JX-3P (PG-200)

SERVICE NOTES

First Edition

CHANGES ON IC52

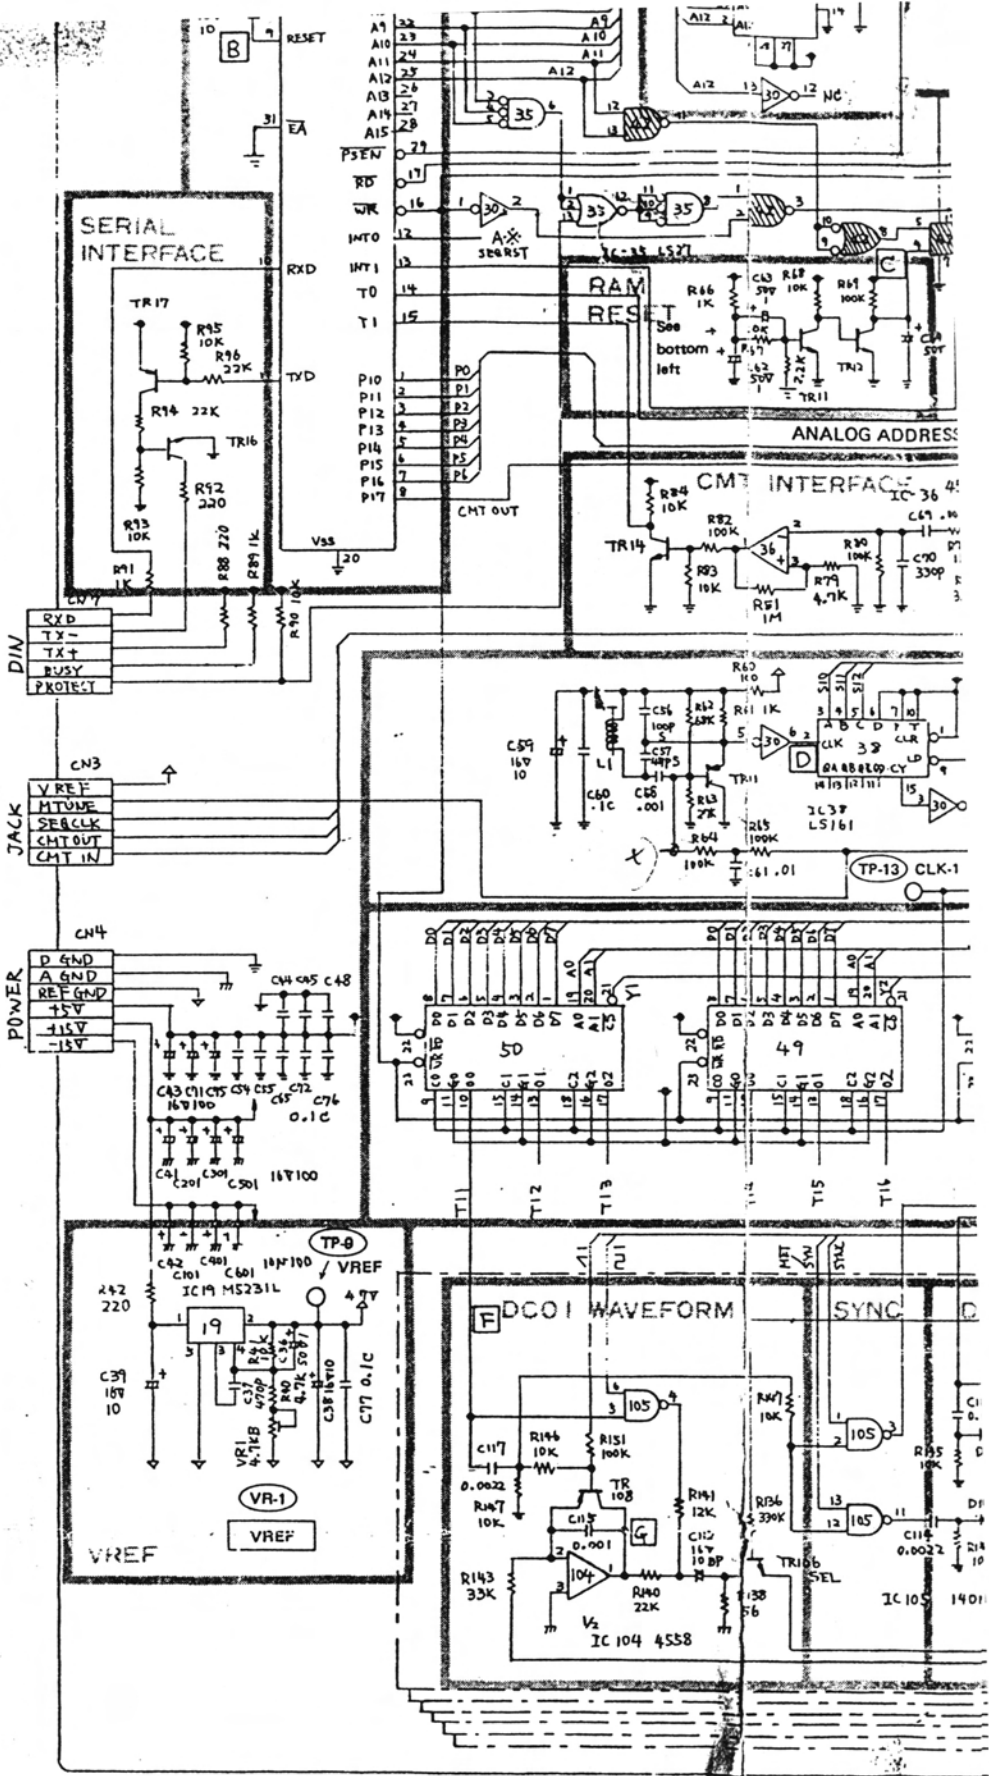
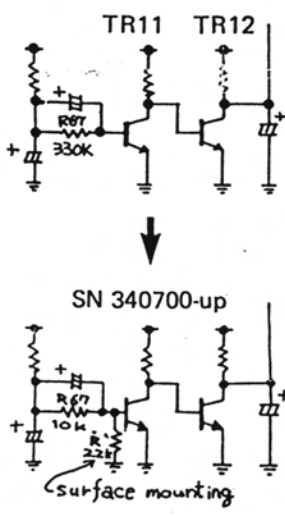
ROM
From EPROM (2764) to MASK ROM (2365) Compatible.
Debugged Program

To cure the problem described below, use the EPROM or MASK ROM of versions A-4 and up for early products, as necessary. Refer to Test Mode in ADJUSTMENT section for identification of existing ROM version.

When the JX-3P is used as a master in MIDI connection, unwanted note may be heard on the slave having more than six voices.

IC.CHANGES

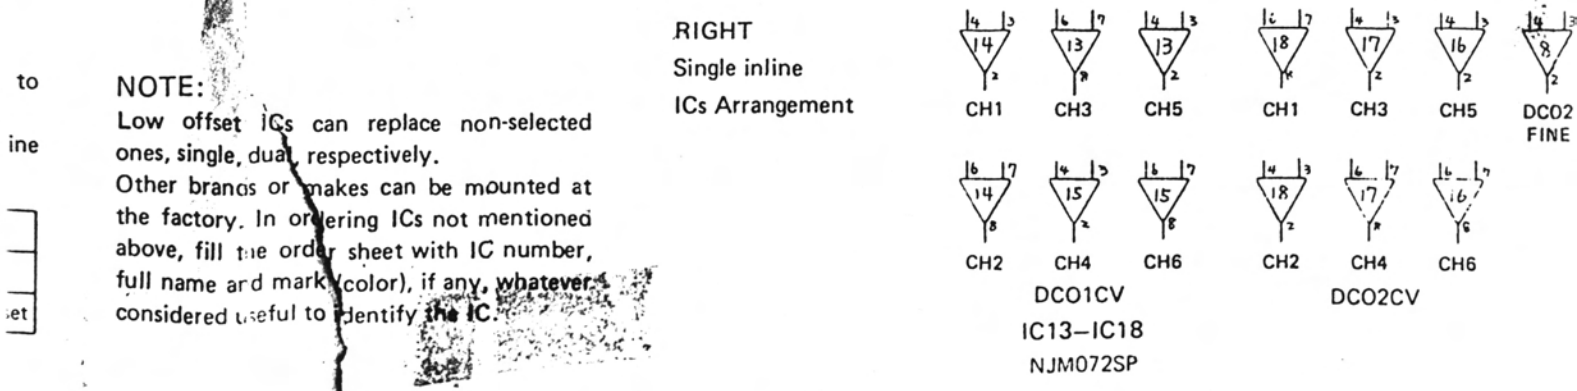
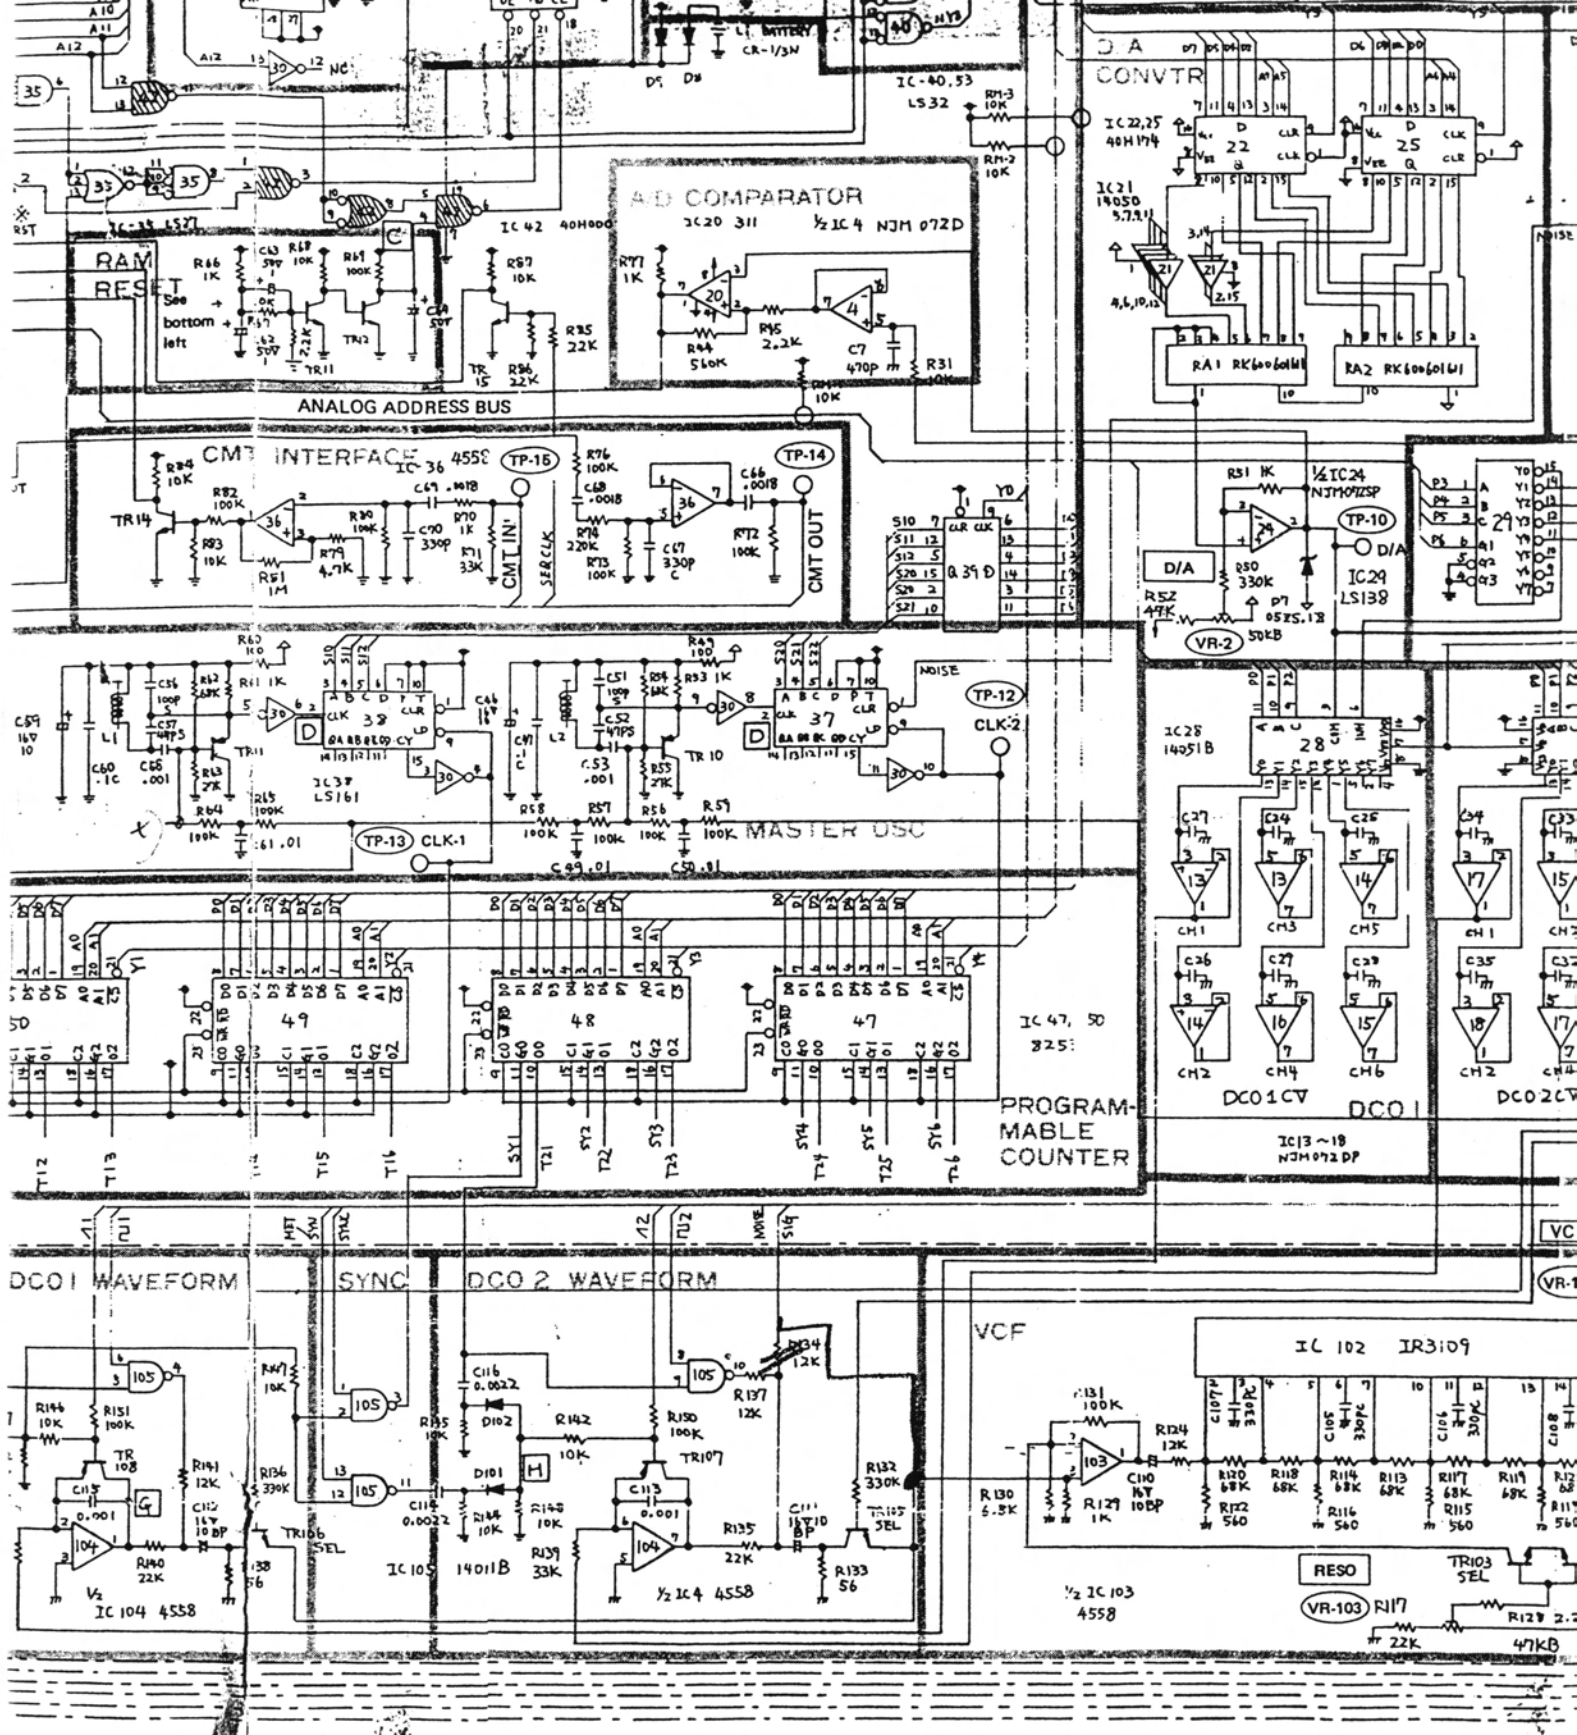
IC procure problems force the factory to emply equivalent on Main board:
IC4-IC18 - from single inline to dual inline with affected PCB foil patterns relaid out.

Single inline	Dual inline	Remark
NJM072S	NJM072D	As produced
NJM072SP	NJM072DP	Selected, low offset

NOTE:
 Low offset ICs can replace non-selected ones, single, dual, respectively.
 Other brands or makes can be mounted at the factory. In ordering ICs not mentioned above, fill the order sheet with IC number, full name and mark (color), if any, whatever is considered useful to identify the IC.

DIN BOARD (149H216) (pcb 052H451A)

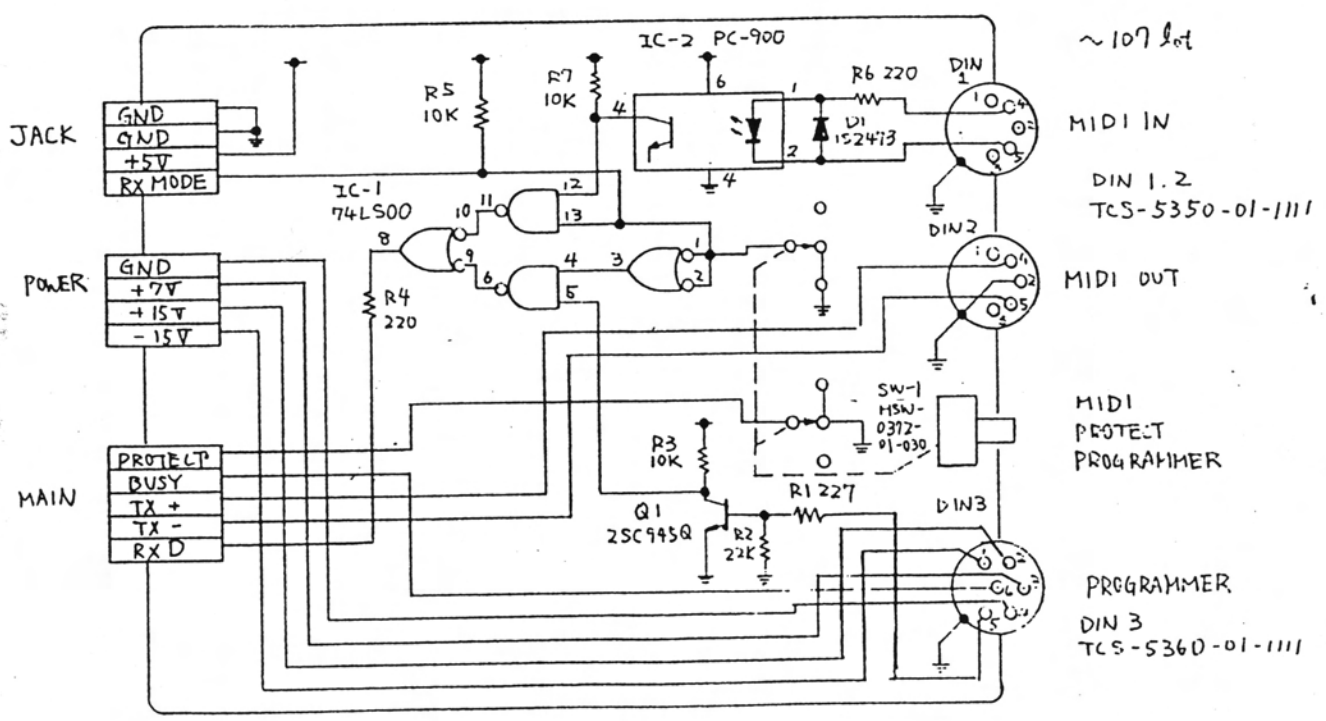
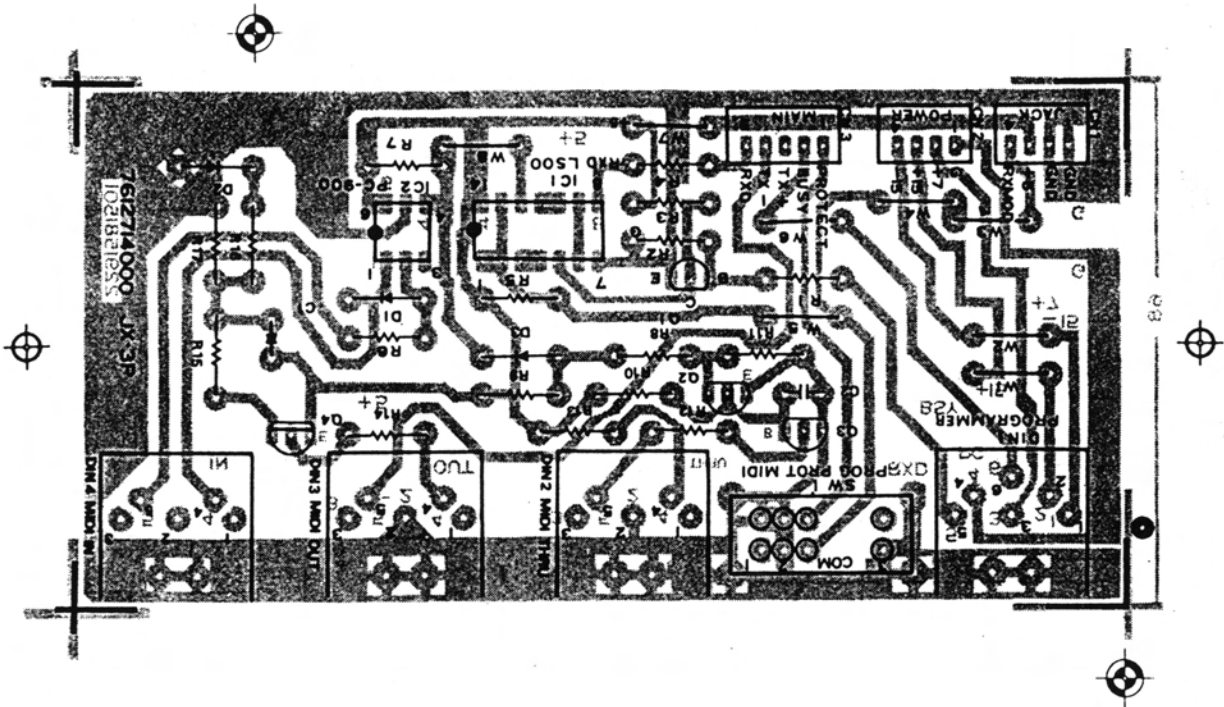
Although both PCBs are compatible, substituting new PCB to o

o old one needs Top panel replacement.

SN 340700 and up
DIN BOARD 7612714000 (pcb 2291581501)

RAM RESET CIRCUIT CHANGE

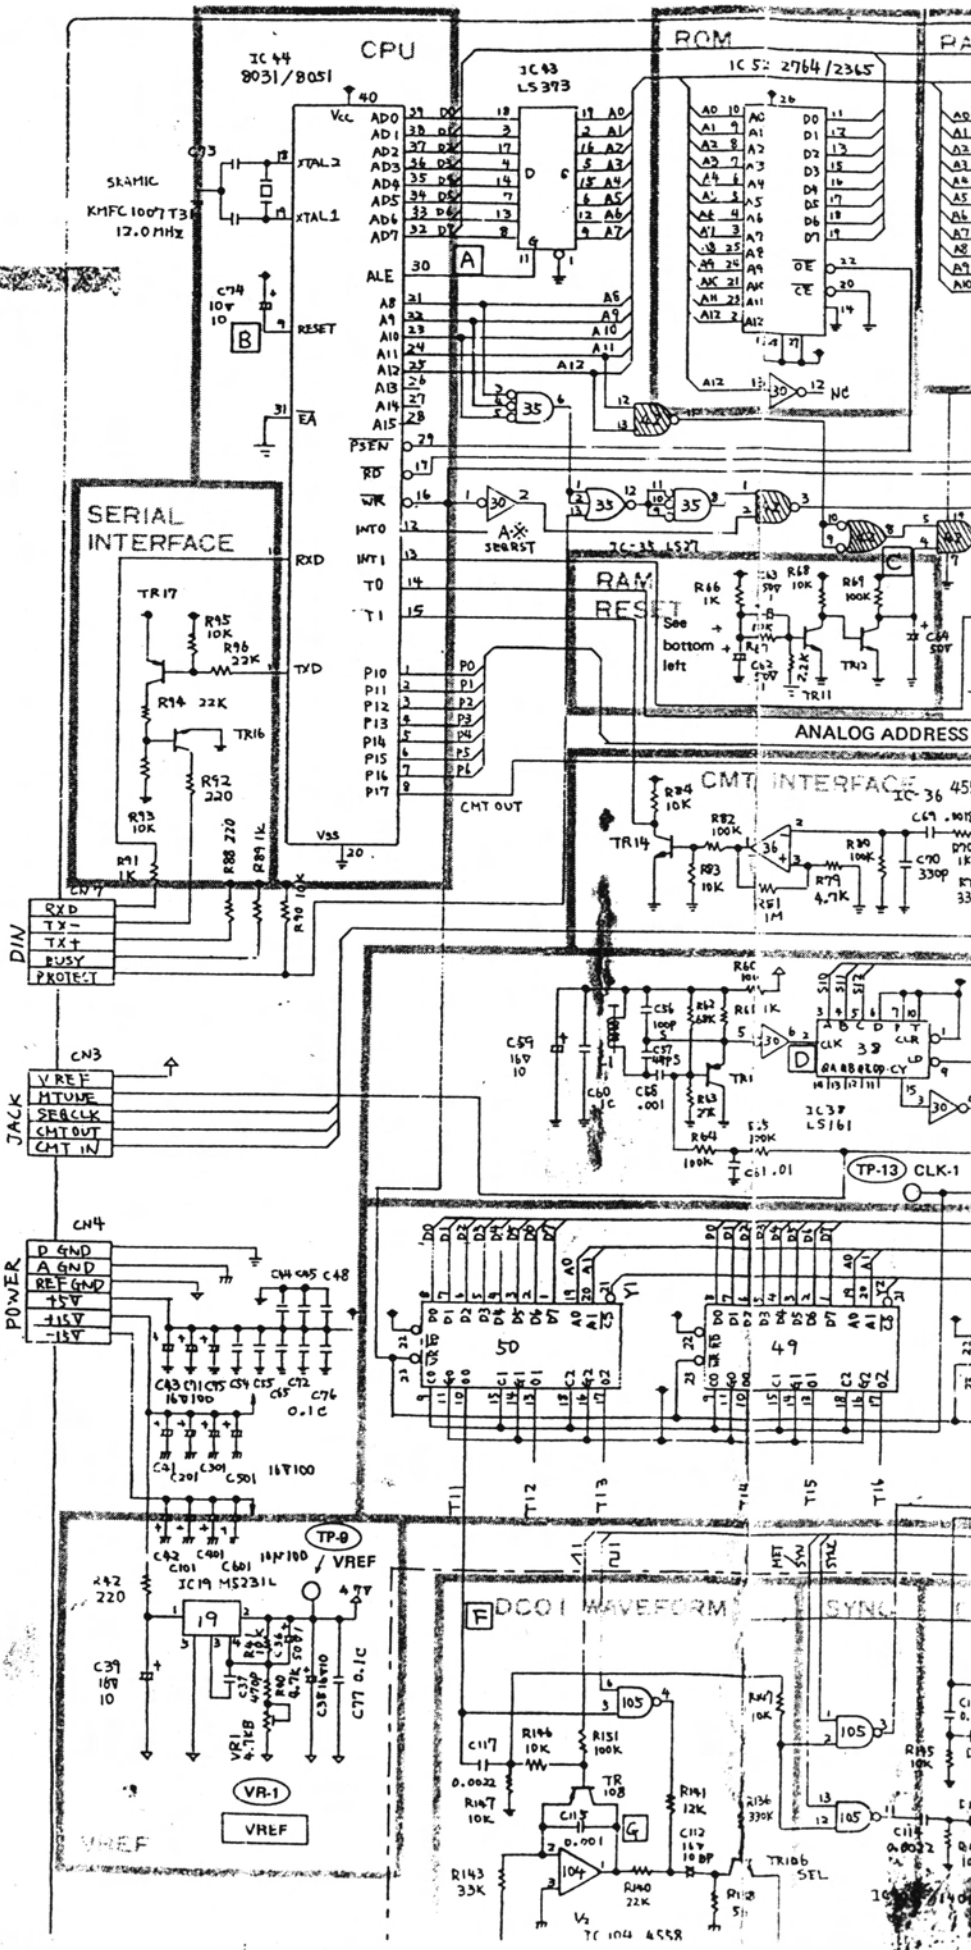
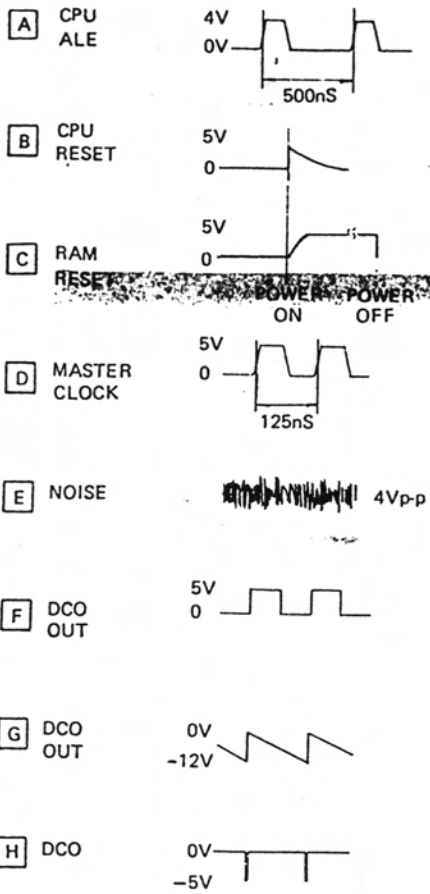
Reason
To make the JX-3P invulnerable against power line transients.

This minor reconnection is effective to cure the problem, "program overrun" when the JX-3P is operating from a greatly fluctuating power line.
